SERVICE BULLETIN

REPLACEMENT OF VALVE SPRING RETAINER ON SINGLE VALVE SPRING CONFIGURATION OF ROTAX® ENGINE TYPE 912 AND 914 (SERIES)

SB-912-022
SB-914-011

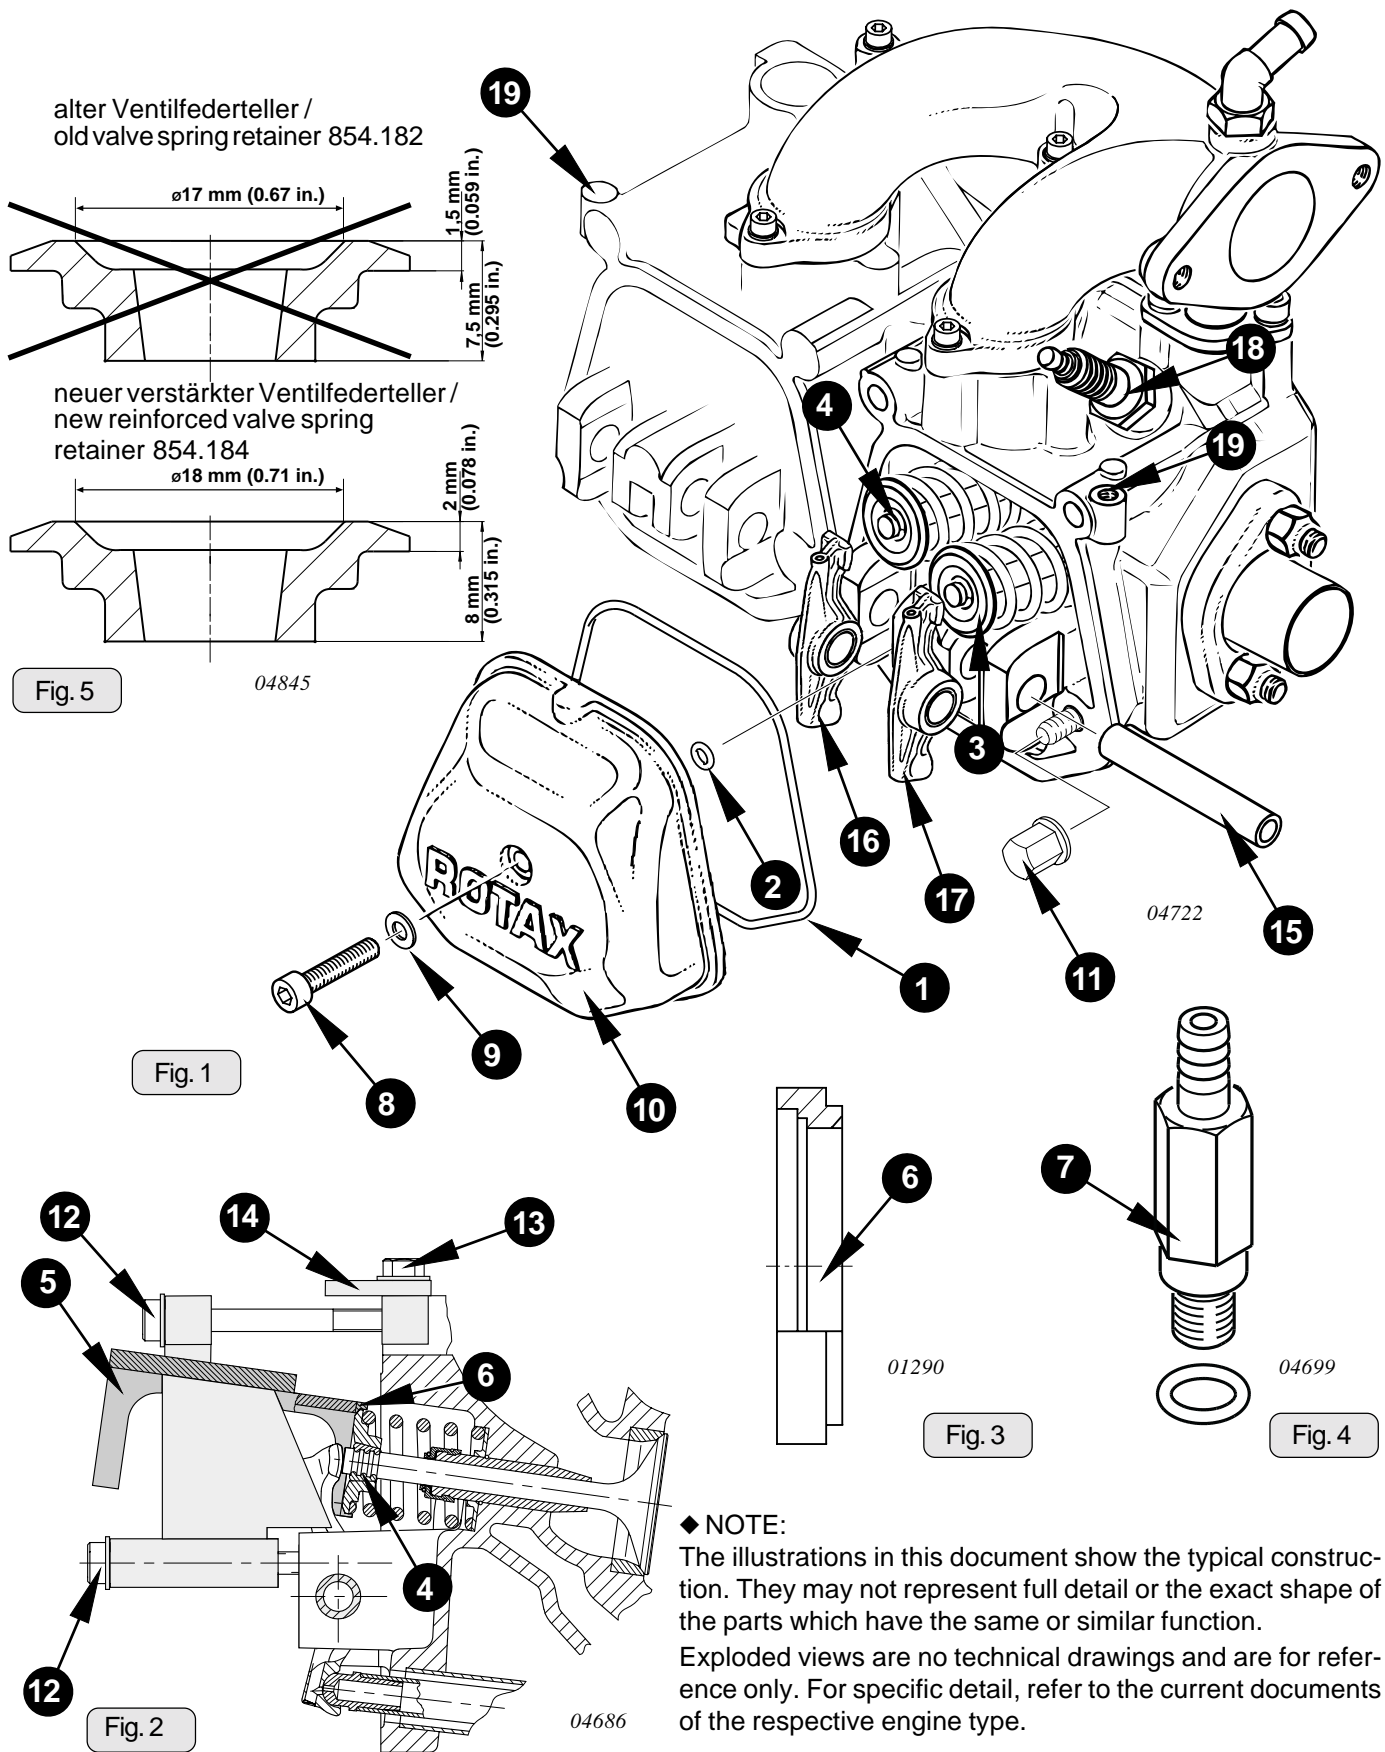
It has been discovered that during the starting procedure a delayed purging of the lubrication system could occur, which may result in cracking of the valve spring retainer. This condition can occur, if the hydraulic valve tappet has been emptied and filled with air. This is possible at first engine run or at oil change.

A detailed crack detection of the valve spring retainers is very difficult and would have to be performed repeatedly. Due to this fact all affected engines have to be equipped with reinforced valve spring retainers, which are much more resistant.

- Place new reinforced valve spring retainer part no. 854.184 on the valve springs (see fig. 5).
 - ◆ NOTE: To facilitate installation apply a bit of grease so that the valve spring retainer (3) will remain on the valve spring.
